19 123 Rev.B

CADZ Plan Site Plan dated
29 May 2024 added to report

30 May 2024

Stormwater Amendment Report for Lot 1 DP 184536 at 36 Old Hospital Road, Whangaroa – BC-2022-988

Site plan by CADZ Plan dated 29 May 2024

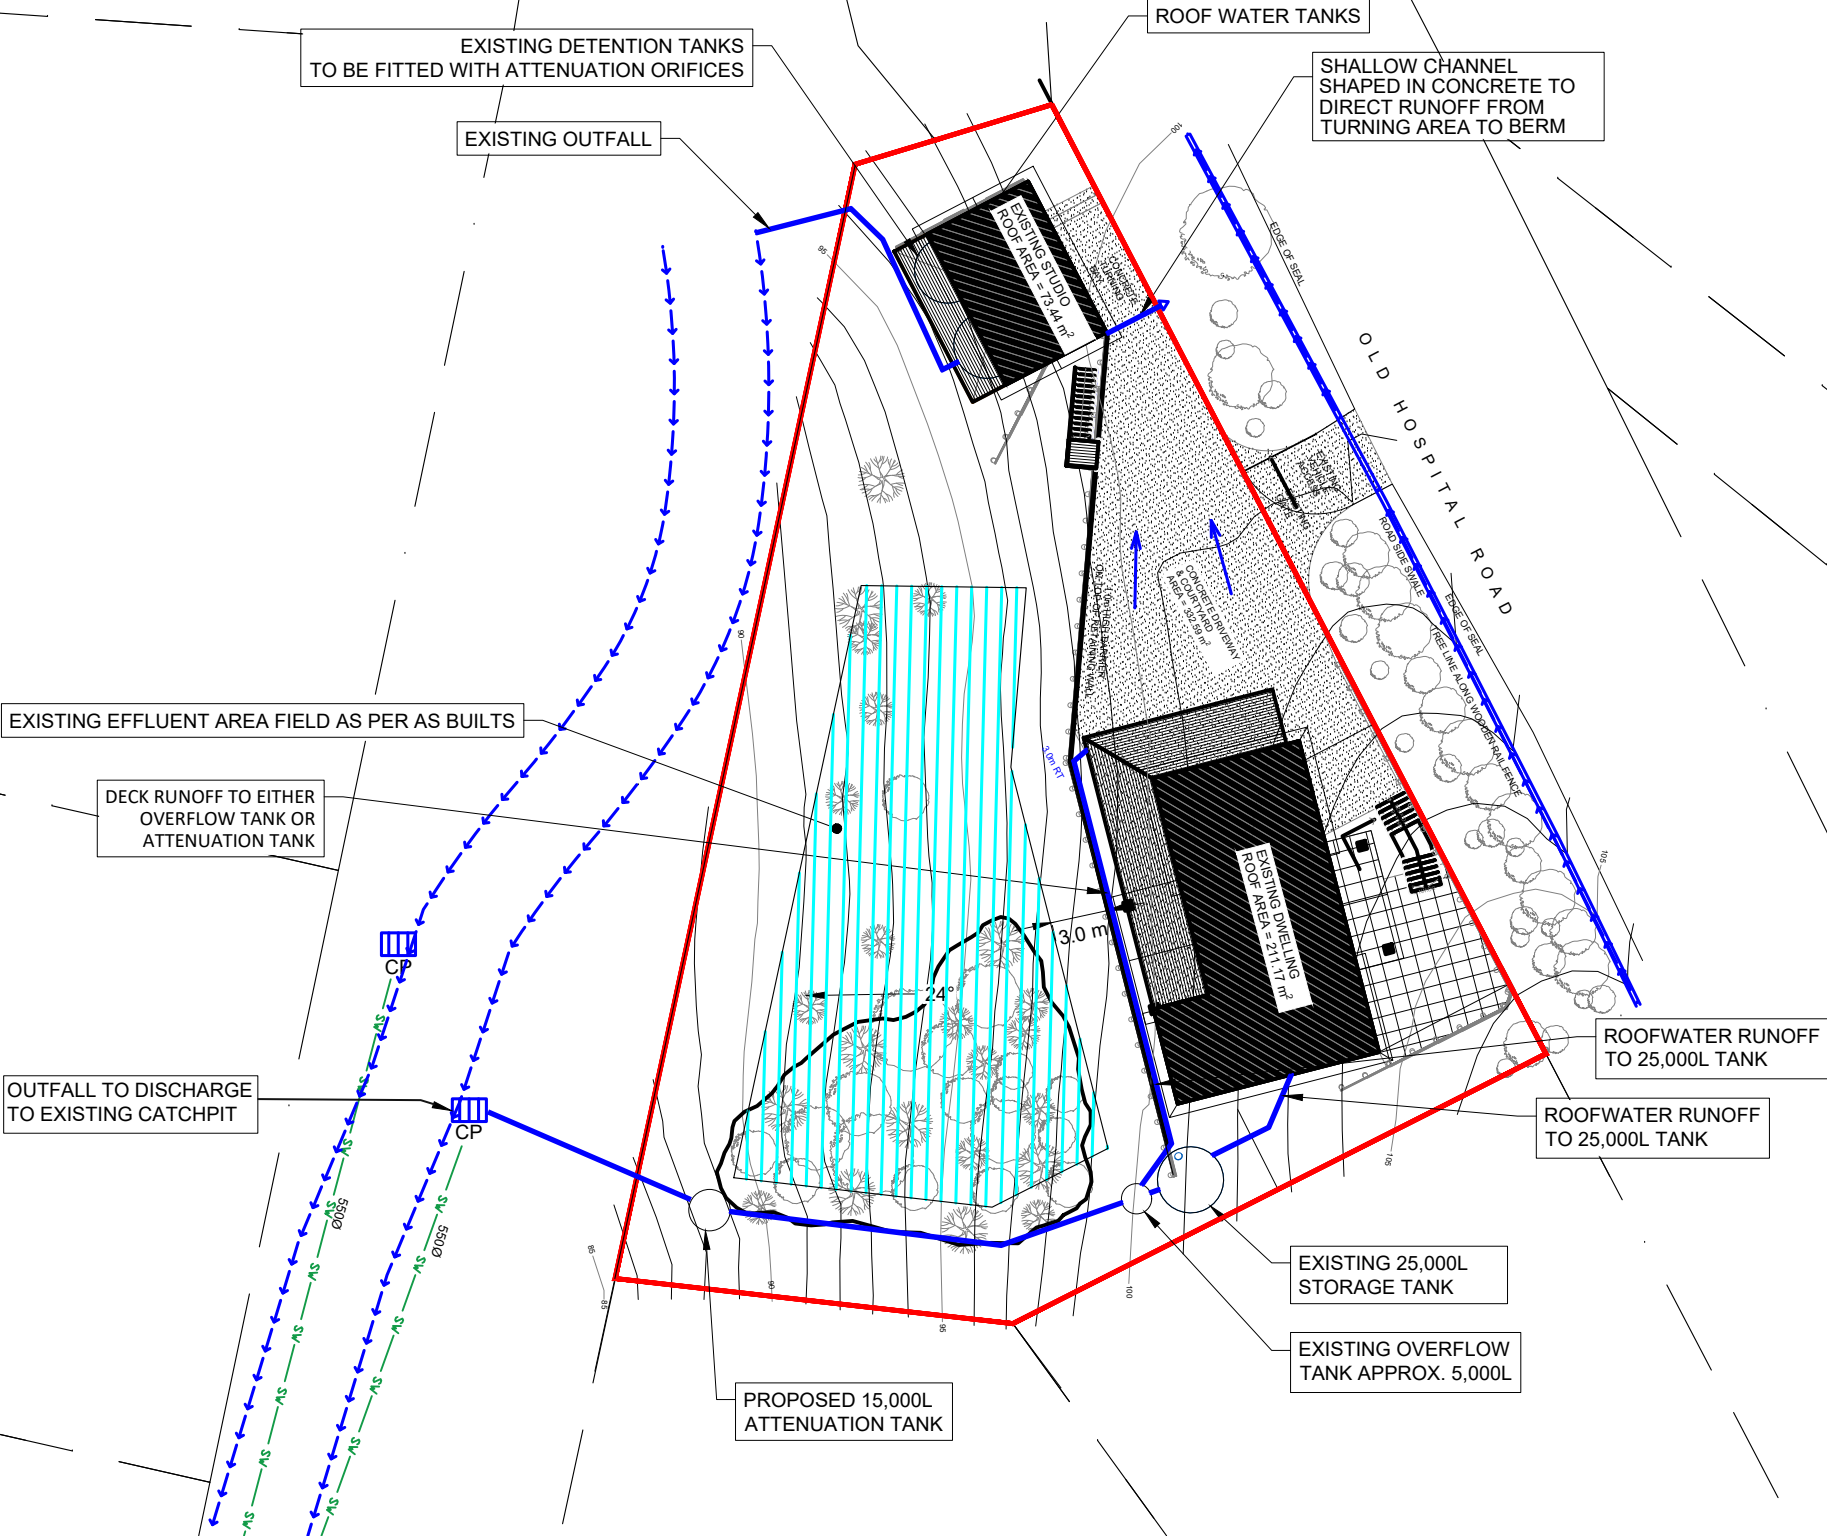
Rather than sacrificing water storage from the existing house tank it is proposed that a new dedicated detention tank be installed at the southwest corner of the site. The tank will be fed by an outfall from the existing overflow/irrigation tank. Roof and deck runoff shall ultimately be piped along the southern boundary to this new tank. The tank shall have a volume of 15,000L and be fitted with a 15 mm orifice at the base of the tank. This would reduce peak flow by 6.0 L/s as shown in the enclosed chart. A filter shall be installed at the inlet to prevent debris collecting in the tank as shown in the enclosed schematic. The outfall from the tank shall discharge to the existing catchpit on the road as shown in the attached drawing.

The BC shows runoff from the manoeuvring area discharging to a central manhole and then piped to the western boundary. It is proposed that, instead, stormwater is discharged to the berm on the eastern side of the site. Minor shaping of the basecourse and formation of a shallow -channel will be required to direct runoff to the identified outfall.

Figure 2: Potential orifice arrangement

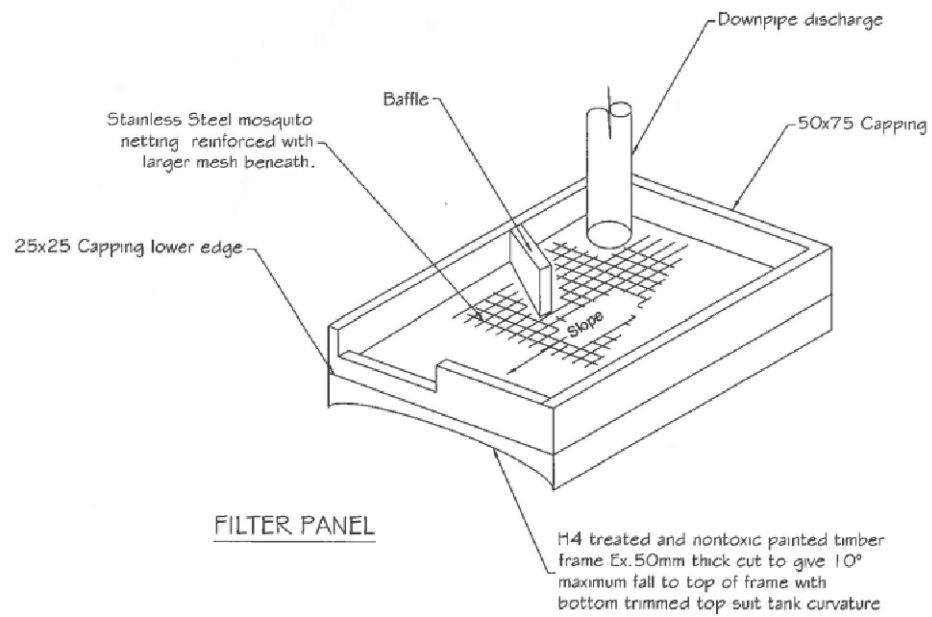
To provide sufficient attenuation for the site, the studio tanks also need to be modified. Each tank shall be fitted with a 15 mm orifice, 300 mm below the invert of the overflow pipe. This would reduce peak flow from the studio by 1.6 L/s as shown in the enclosed chart. A potential arrangement is shown in Figure 2. A baffle shall be installed at the attenuation orifice as shown in the enclosed schematic.

Hydrographs for House in 10 year ARI storm

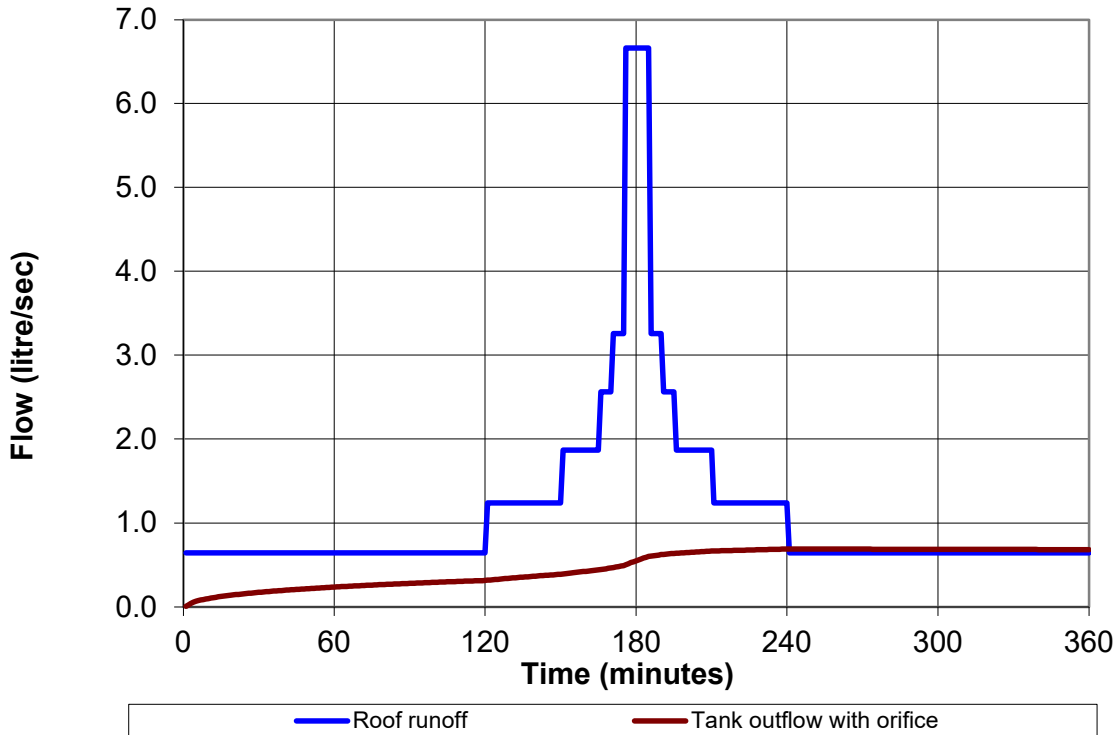
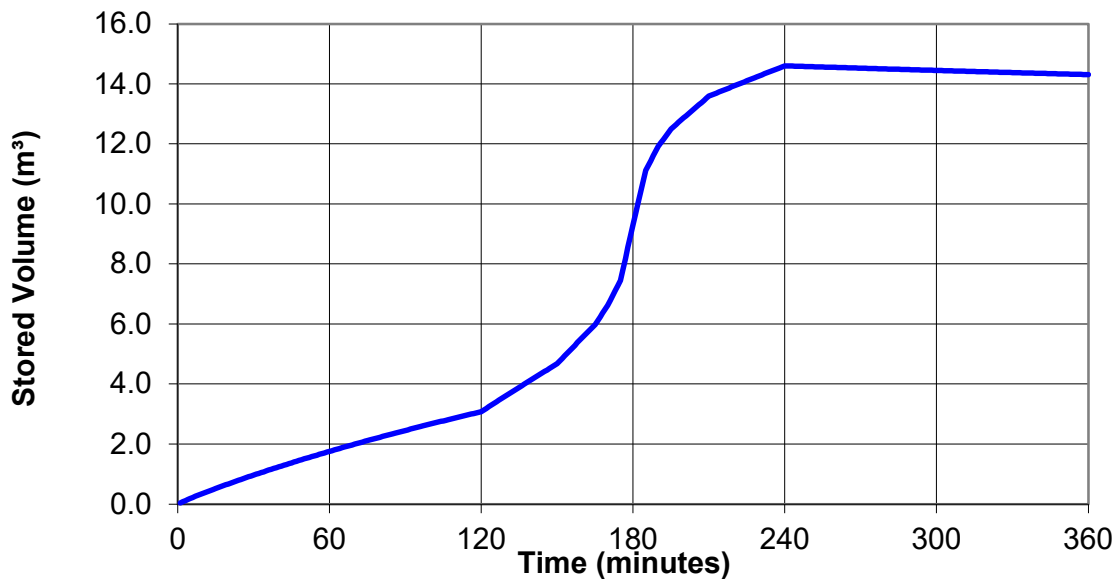
Project:	Residential development	House roof and deck area	244 m ²
Location:	36 Old Hospital Road, Whangaroa	Tank Diameter	3.0 m
Client:	Jenny Morgan	Area of tank	6.8 m ²
Designer:	RH	Diameter of orifice	15 mm
Date:	22/02/2024	Maximum attenuation	6.0 l/s

site plan 1:200

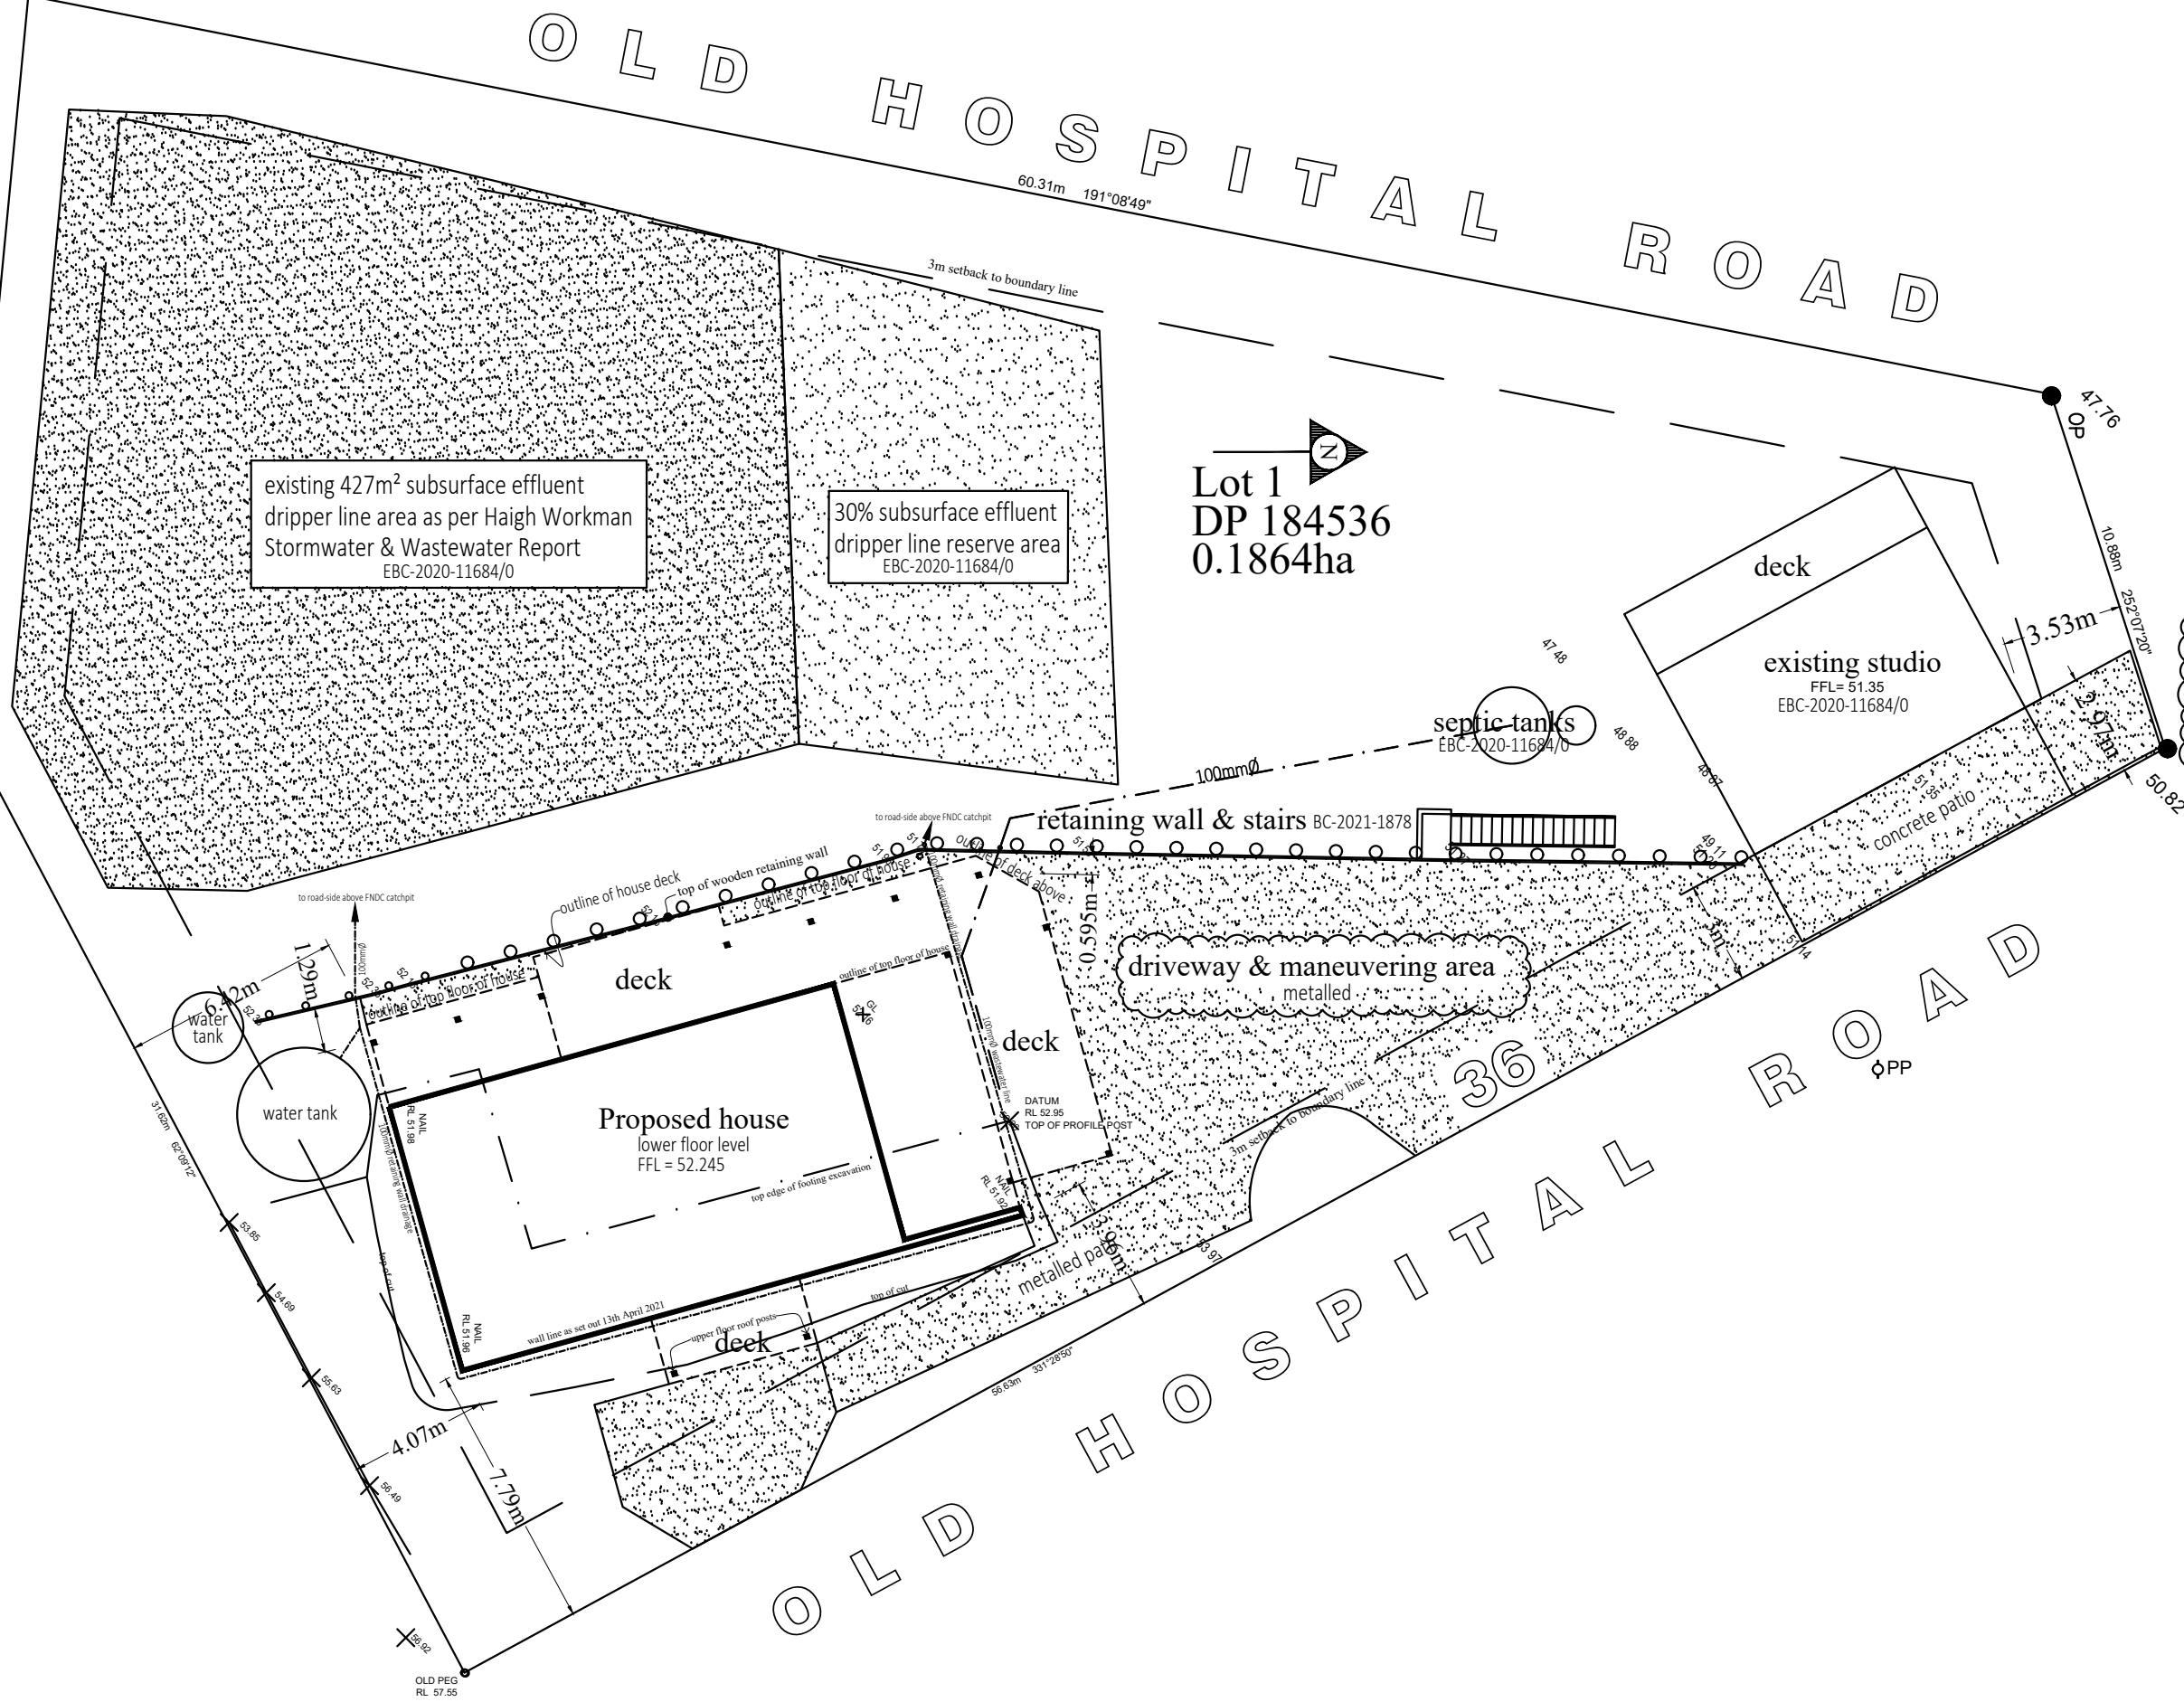
amendment: driveway concrete apron deleted- driveway will be metalled
licence to occupy application for 2- 10,000litre water tanks (for fire fighting purposes)
on road reserve at northern edge of property
